Dragon OOD-SI-3130 (7/15)

Fig. 2.6.

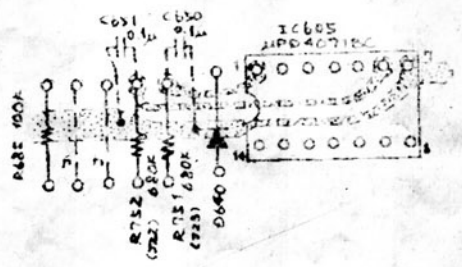
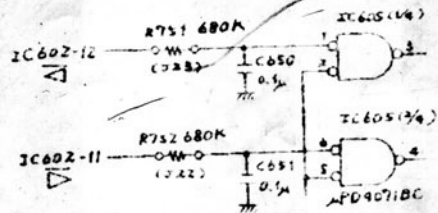
- 1) The RC Delay circuitries have been added to the Direction Switching signals at the Reel Drive circuit section on the Logic P.C.B. Ass'y as shown in the the figure 2.6.

The modification procedures are as follows:

- ① Replace the jumper wires J22 and J23 with the Resistors R751 (680kΩ 1/6W) and R752 (680kΩ 1/6W) on the Logic P.C.B. Ass'y.
- ② Connect the Capacitors C650 (0.1μF) across the pin number 1 of the IC605 (μPD4071BC) and the ground, and C651 (0.1μF) across the pin number 2 of the IC605 and the ground.
- ③ Check whether the modification is made correctly.
